**Manor Road.
Richmond.**
**Avanton Richmond
Development Ltd.**

ENERGY STRATEGY
RESPONSE TO ADDITIONAL GLA COMMENTS

REVISION 01 – 26 JUNE 2019

This document provides a response to the second round of comments provided by the Greater London Authorities (GLA) on 17/06/2019 to the Energy Strategy prepared by Hoare Lea in support of the planning application for Manor Road, Richmond (case number 4795).

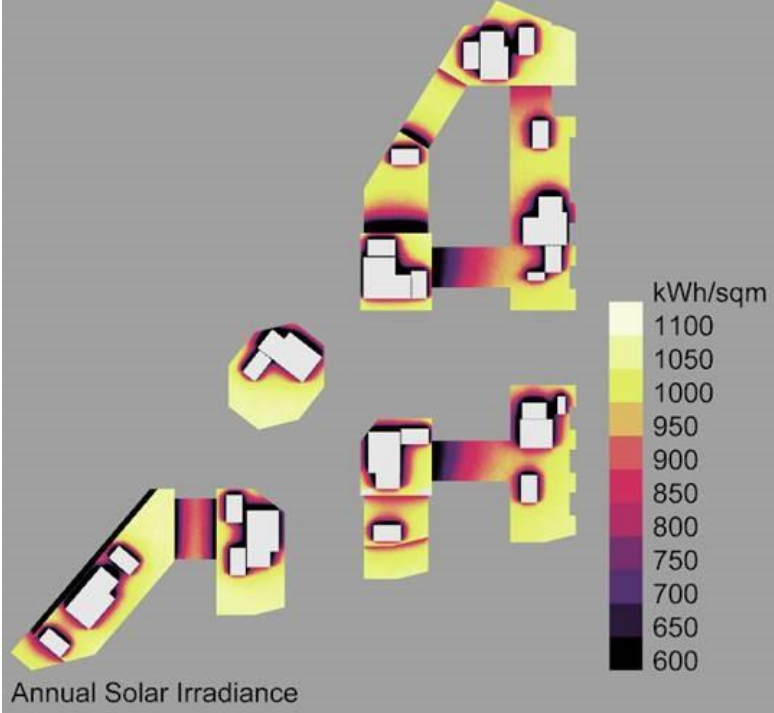
28c	The applicant has provided a datasheet confirming their assumptions, including the runtime and external temperature as per item b. (...) They should confirm the proposed size of the heat pumps.	Approximately 2.8MW of ASHP heating is provided across the site in module sizes varying from 90-250kW.			
28e	A commitment to monitor the performance of the heat pump system post-construction to ensure it is achieving the expected performance approved during planning.	The client has confirmed they will commit to monitoring the performance of the heat pump system post-construction and compare against the expected performance estimated during planning. Suitable commissioning will be carried out of the system to ensure optimised performance.			
29	Solar PV and roof space availability: the applicant should provide further detail and provide solar insolation levels.	A solar irradiance study of the roofs has been completed – see image below. Due to some updates in the allocation of plant space, it would be prudent to move two of the arrays, however the over-all estimated allocation is unchanged (140m ² of PV panel area). See updated mark-up attached. Grey areas in the attached are allocated for

Item #	Query	Team response
		<p>mechanical plant space or overshadowed areas, red areas are areas that are deemed too small for a PV array (less than 15 panels would fit).</p> <p>Further PV allocation is not deemed suitable for the following reasons:</p> <ul style="list-style-type: none"> - All remaining unshaded locations would only allow for small arrays (<15 panels each). - Such small arrays would have a negligible impact on the carbon emission reductions for the development - Small PV arrays are less efficient due to inverter losses (each array would need a separate inverter) - The development is already expected to achieve in excess of 35% carbon emission reductions based on the current design. 
32	<p>The applicant has confirmed that they have currently omitted the CO₂ emissions reduction associated with PV. Once all other comments are resolved, they should provide updated CO₂ emissions reductions for all stages of the energy hierarchy, including the CO₂ emissions from PV.</p>	<p>To clarify: We have not omitted the carbon emission reductions from our calculations, however they are not included in the SAP calculations for the apartments at the current point in time, but were added to the calculations separately. Updated CO₂ emission reductions at each stage of the energy hierarchy are set out in the Appendix E. This includes the additional PV array identified by the team in the previous response (i.e. total array now 140 m² PV panel area).</p>
